# Bullitt County Public Schools

TO: Dr. Jesse Bacon  
FROM: Bret Highley *ABH*  
DATE: July 22, 2021  
RE: New 800 Student Elementary School  
Bid Package 1 – BG 20-142 Change Order #5

Re: Old Mill Elementary School  
RFP 06 and 6a – HBC Door Revisions

PROJECT:	OLD MILL ELEMENTARY SCHOOL 199 Golden Wing Road Mt Washington, Kentucky 40047	REQUEST FOR PROPOSAL NO.:	06
OWNER:	Bullitt County Public Schools 1040 Highway 44 East Shepherdsville, KY 40165	DATE:	24-May-2021
TO CONTRACTOR:	Redlee Construction & Development 800 Stonecreek Pkwy, Suite 5A 800 Stonecreek Pkwy, Suite 5A	ARCHITECT:	Studio Kremer Architects 1231 S Shelby Street Louisville, KY 40203
		ARCHITECT'S PROJECT NO.:	2019-50 BG# 20-142

A1.4A

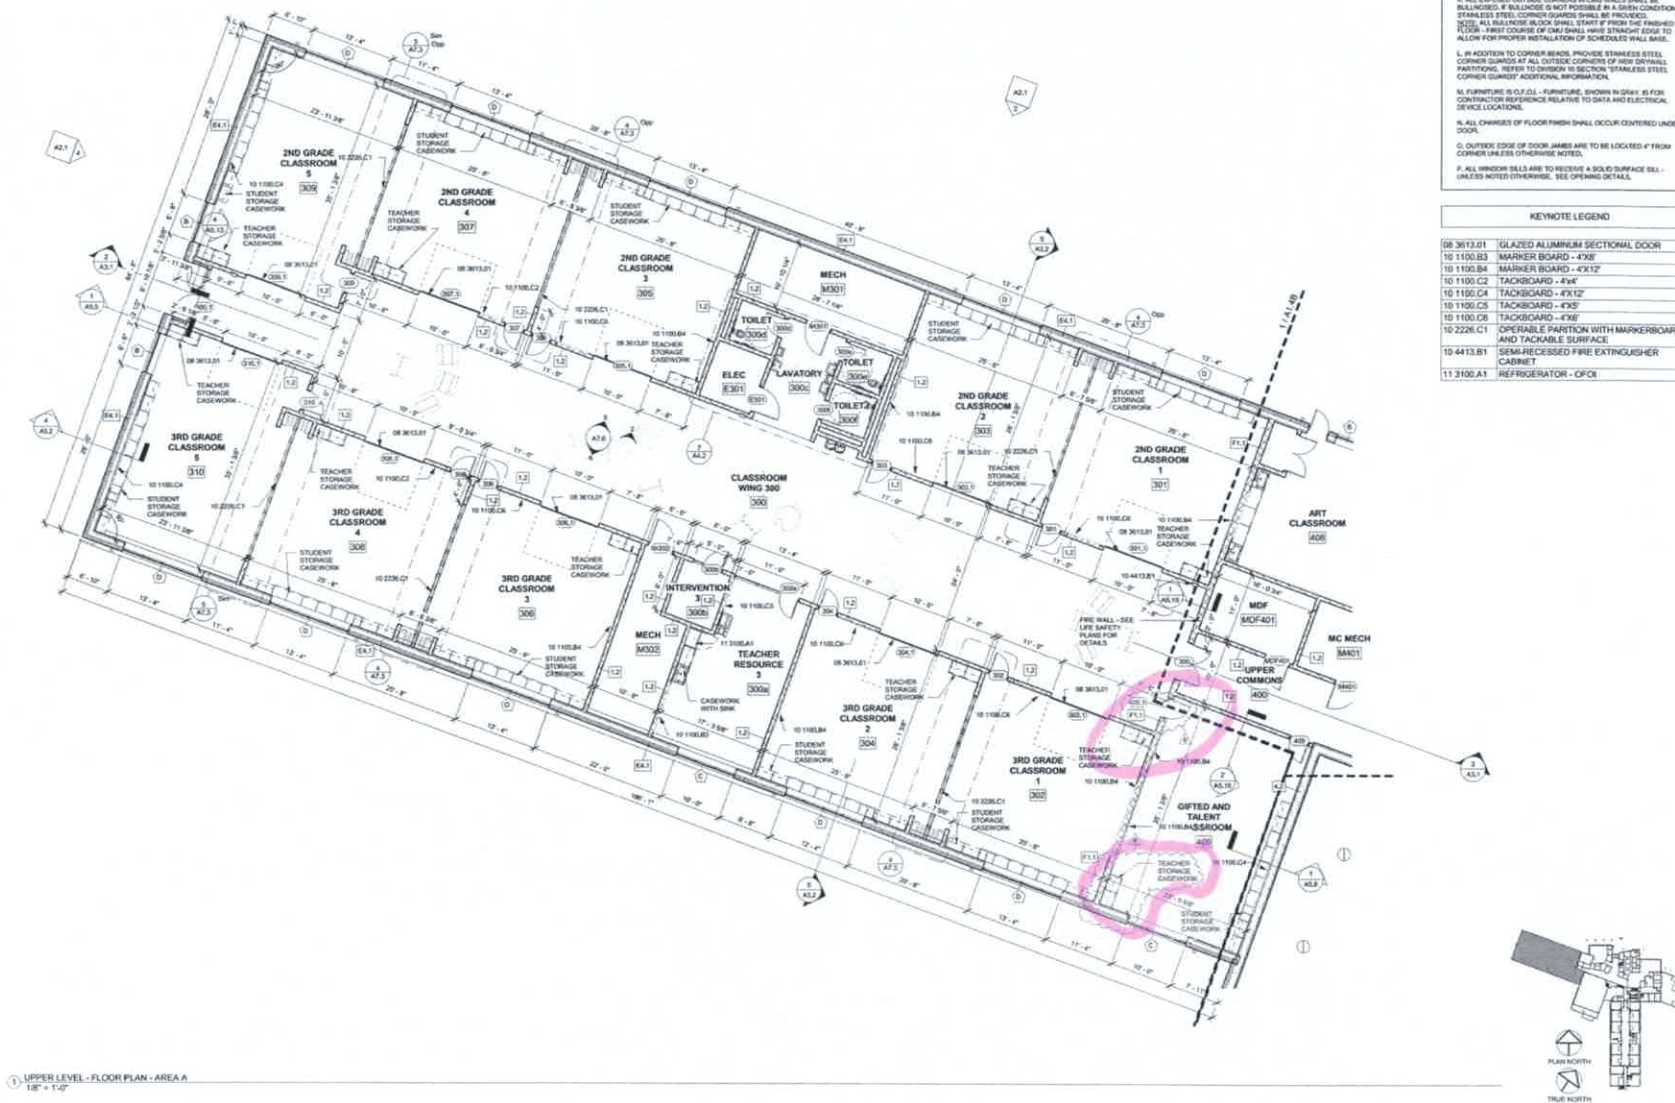
- Item A5:** Add Door 409.1 to Area A fire wall:
- Add a new door following notes provided on A6.1 Door Schedule. See A1.4A for location.
  - Assign new Door 500b.1 to Hardware Set E12 per the Hardware Change V1a document (page 5 of this RFP).

- Move "Teacher Storage Casework" to south / west corner of room as shown on plan A1.4A. See Electrical Scope.
  - Provide lintel at new door.
- Item A6:** Revisions to Door 500.1:

**SKE2.1A.1**

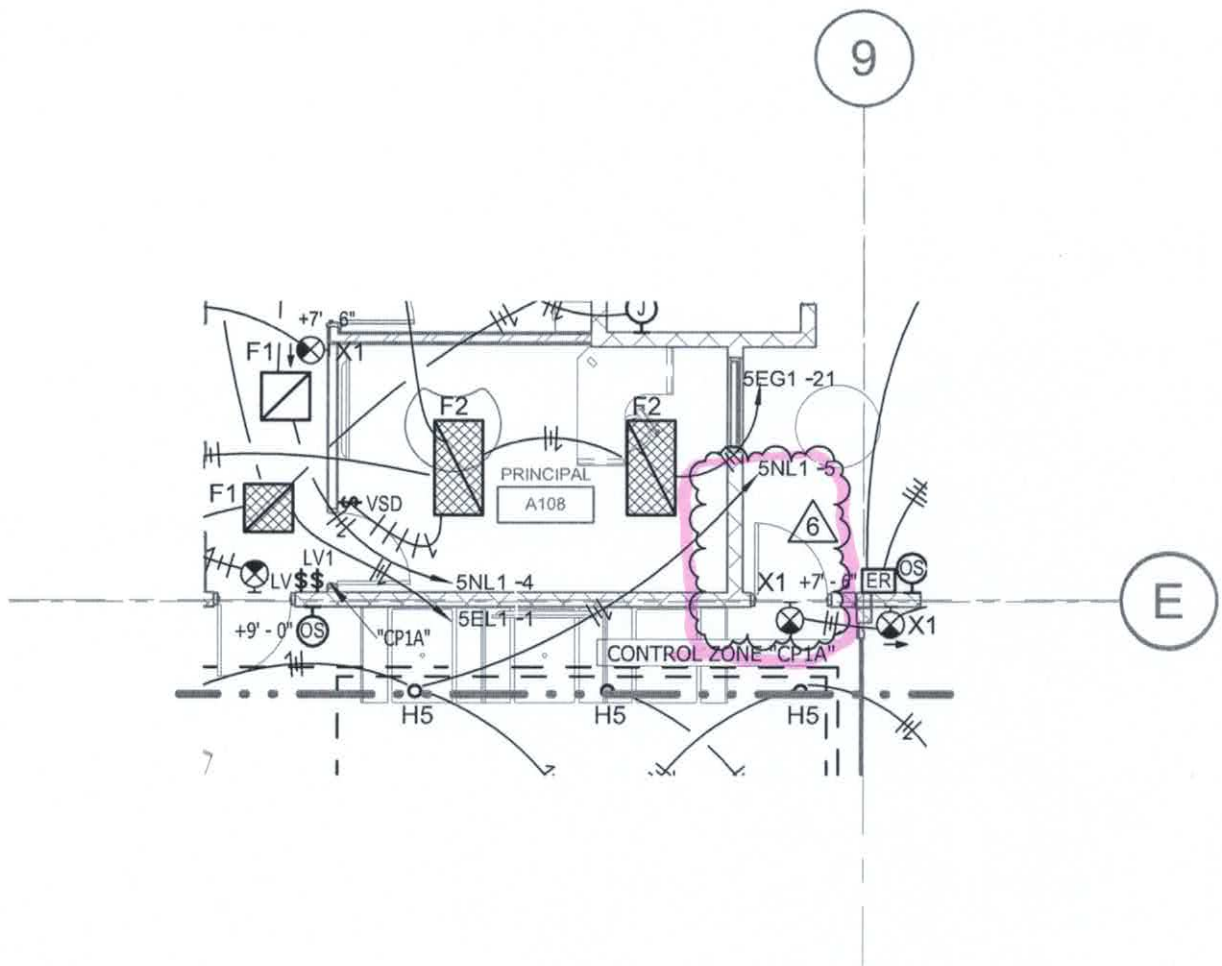
- Item E1:** See SKE2.1A.1 – Add additional \$LV1 lighting control rough-in and device for new plan north-west door.  
Relocate vacancy sensor.
- Item E2:** See SKE2.1B.1 – Relocate exit sign from interior of Cafeteria 500b to interior of Cafeteria 500a to correlate with door swing flip. Remove directional arrows.

**SKE2.1B.2**

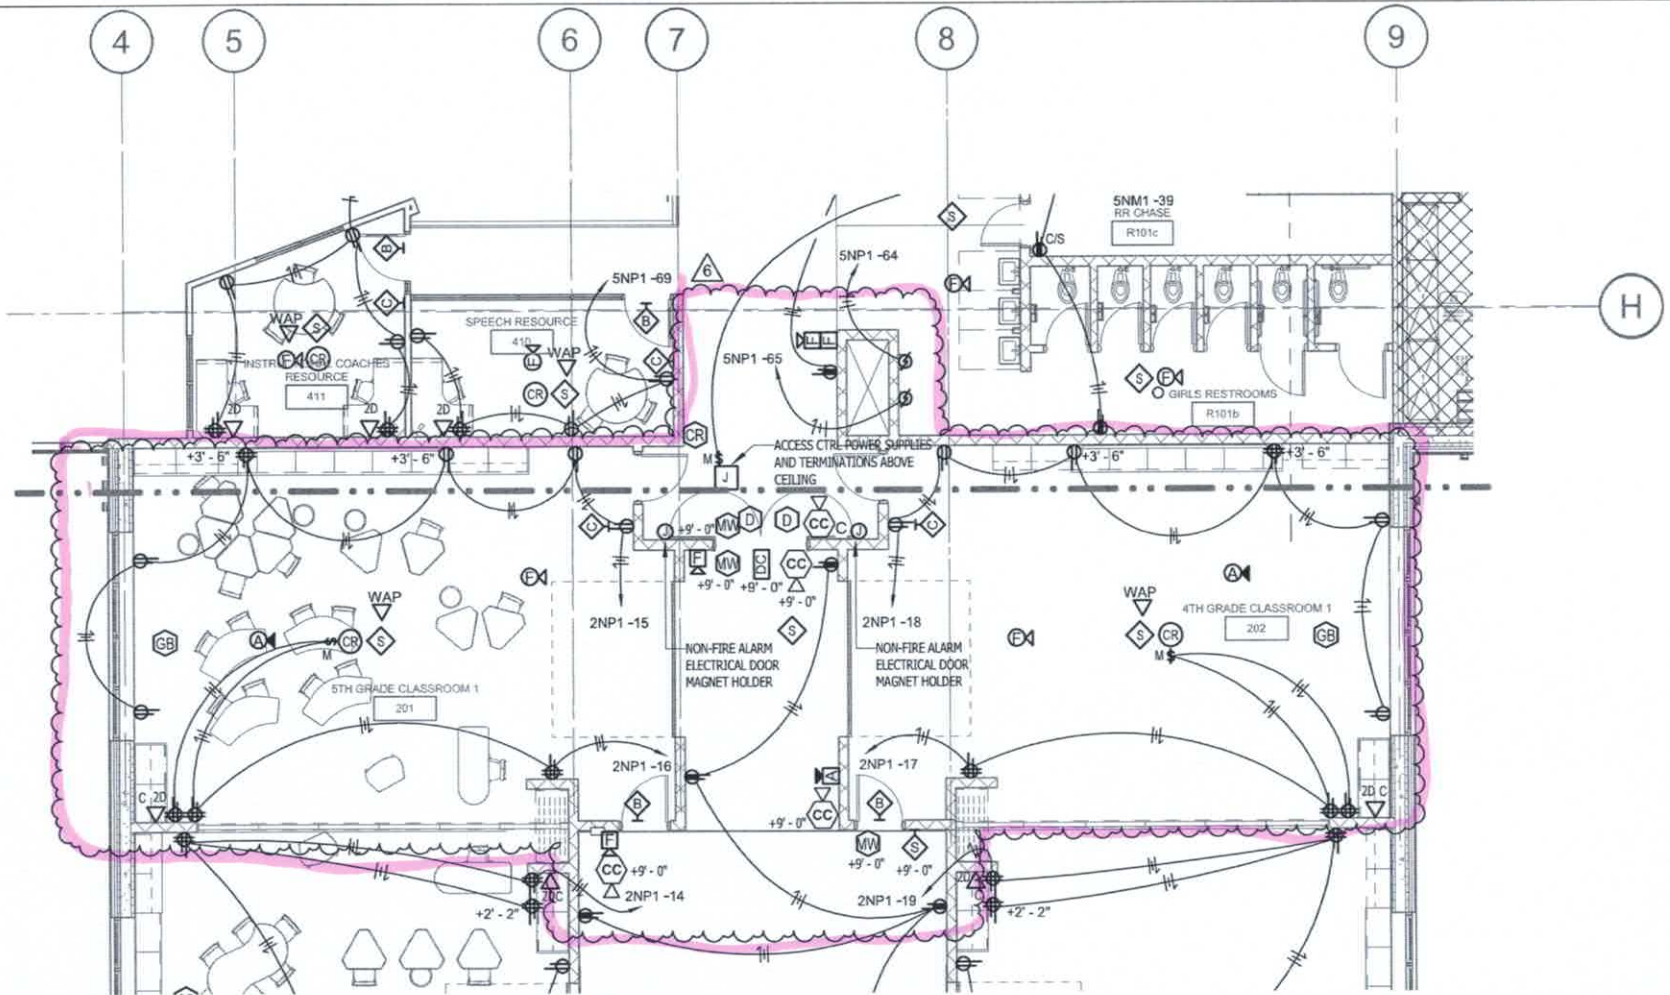
- Item E3:** See SKE2.1B.2 – Provide new exit sign and circuiting tied into life safety circuit for additional egress door out of Cafeteria 500b adjacent to Garden Storage GA101.

SKE3.1C.1

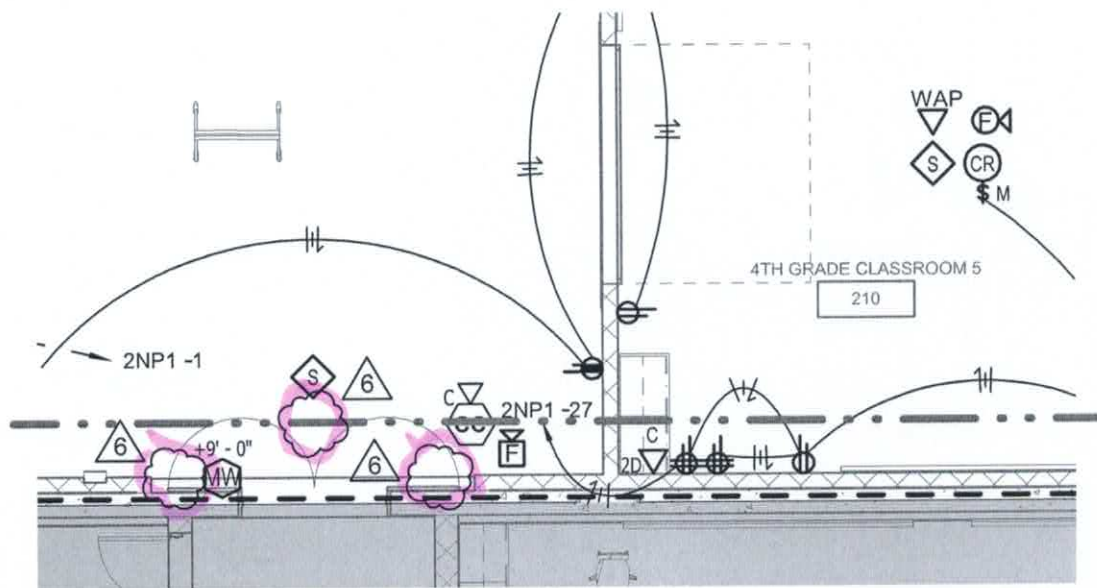
- Item E6:** See SKE3.1C.1:
- Revise location of devices for shift south of double door in hallway.
  - Revise location of devices south of classrooms in corridor for door at each classroom

- Refer to Classroom 201
- Relocate intercom call button to new door at plan north of room.
  - Relocate Teacher station and associated power and data rough-ins to south-west corner of room.

- Revise room circuiting and device layout.
- Refer to Classroom 202
- Relocate intercom call button to new door at plan north of room.
  - Relocate Teacher station and associated power and data rough-ins to south-east corner of room.

SKE3.1D.1

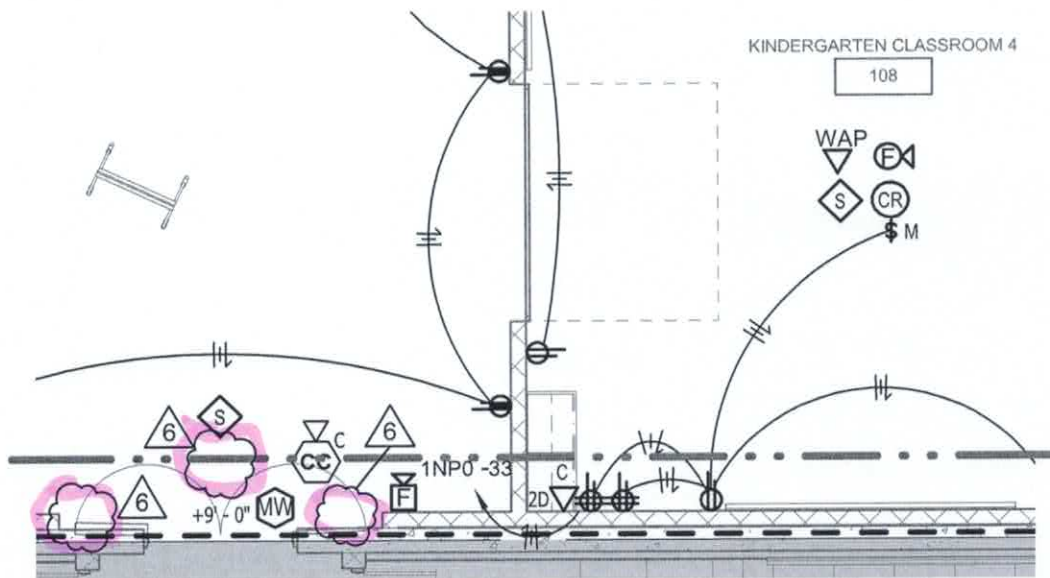
- Item E7:** See SKE3.1D.1 – Remove Fire Alarm door holders and smoke detector control.
- Item E8:** See SKE3.2D.1 – Remove Fire Alarm door holders and smoke detector control.
- Item E9:** See SKS-E0.1.3 – Remove access control power and rough-in from Stair S101a entry.

SBA2.1C.1

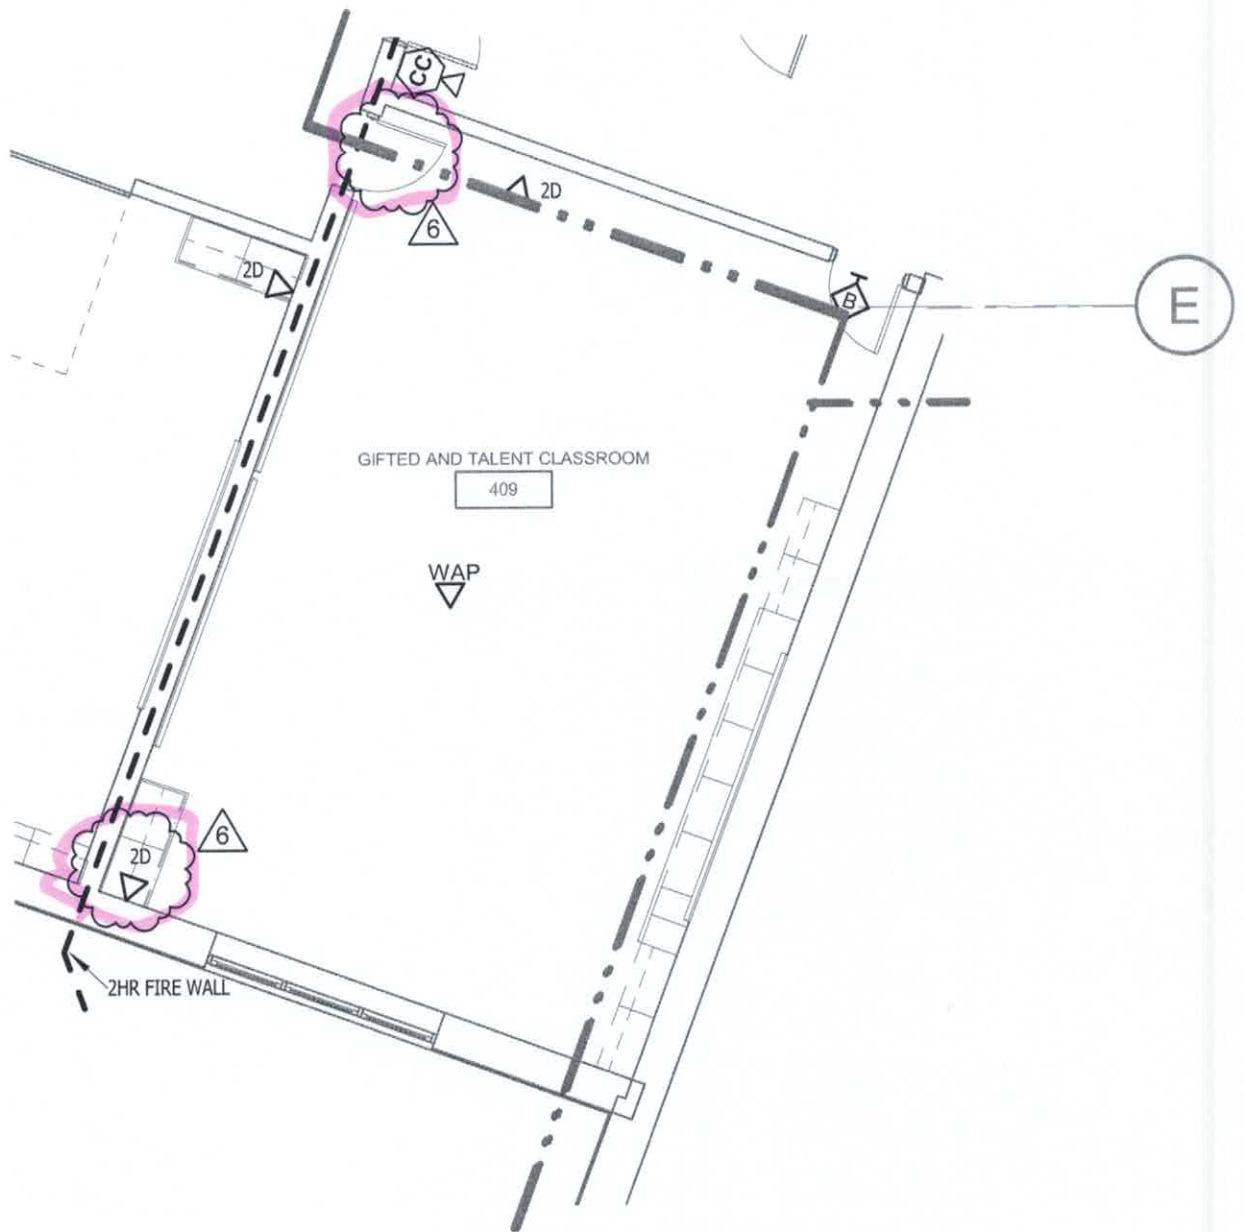
- Item E10:** See SBA2.1C.1 – Relocate thermostat/sensor and carbon dioxide sensor for new door as indicated in both classrooms 201 and 202.

**SKT1.1A.1**

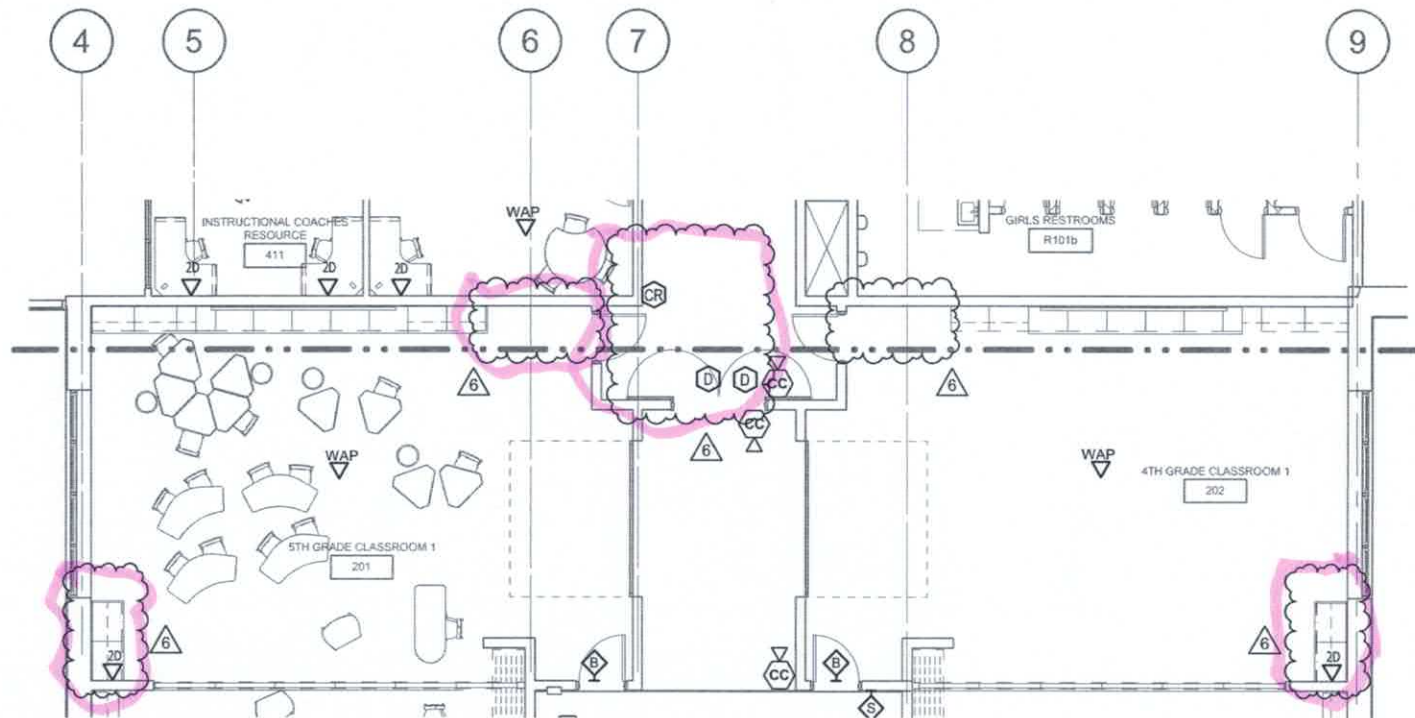
- Item E11:** See SKT1.1A.1 - Relocate Teacher station and associated data rough-in to south-west corner of room
- Item E12:** See SKT1.1C.1:  
 - Revise location of devices for shift south of double door in hallway.  
 Refer to Classroom 201  
 - Relocate Teacher station and associated data rough-in to south-west corner of room.  
 Refer to Classroom 202  
 - Relocate Teacher station and associated data rough-in to south-east corner of room.
- Item E13:** See SKT1.2E.1 – Remove access control from Stair S101a entry.

**PARTIAL PLAN - UPPER LEVEL FLOOR FRAMING PLAN**  
 SCALE: 1/8" = 1'-0"

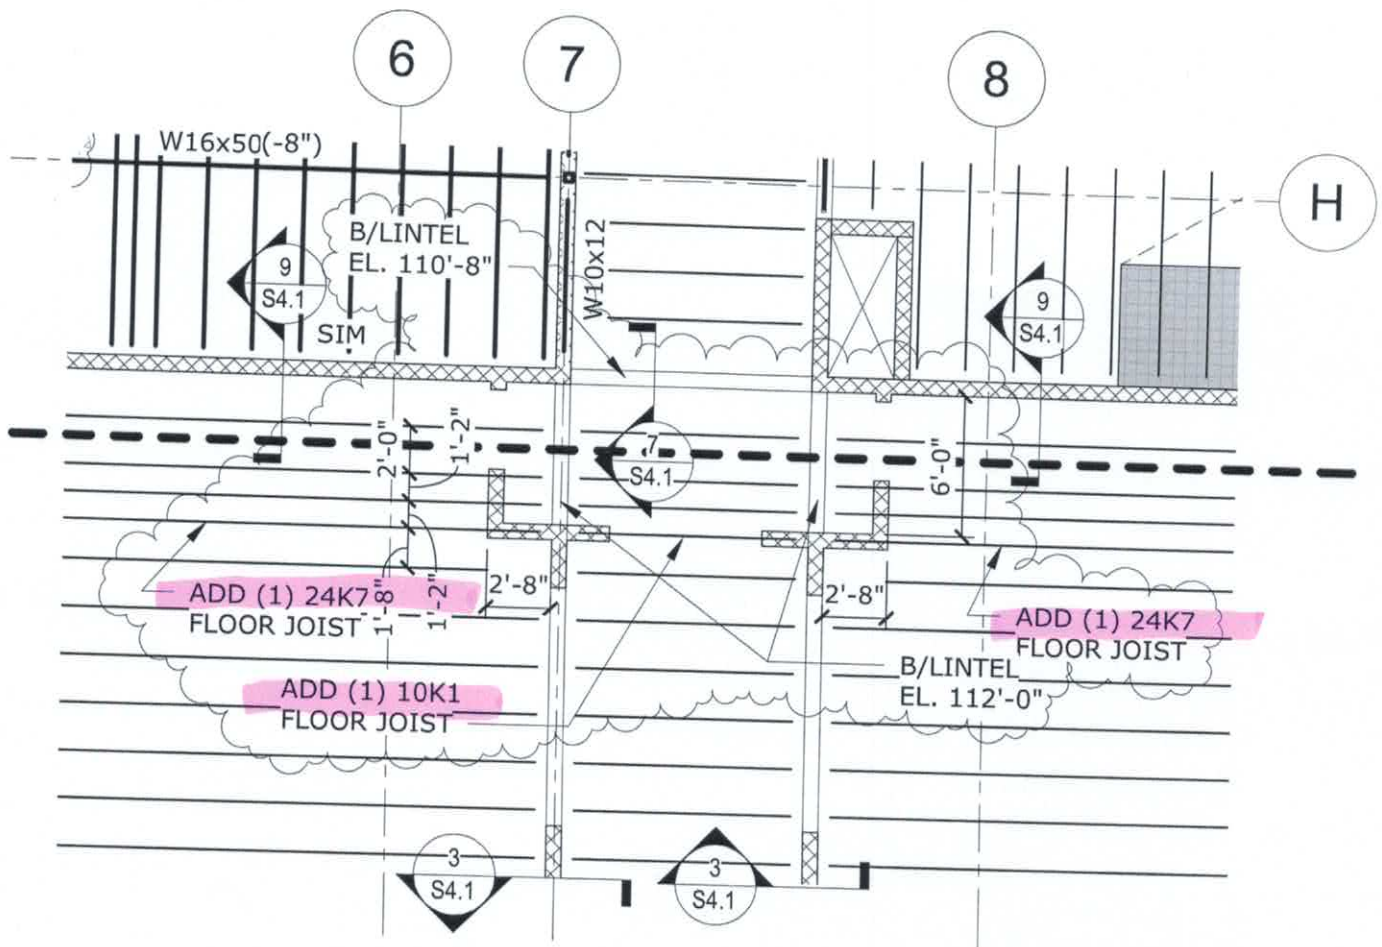
- Item 1:** See attached Structural Sketch SSK6 for structural changes related to HBC required Door Revisions shown in RFP 06.
- Item 2:** Provide L8 CMU Bond Beam Lintels at new door openings 409.1, 201 and 202 following the Lintel Schedule on S1.4.

PROVIDE LINTELS PER  
 MISC. LINTEL SCHEDULE  
 ON SHEET S0.4
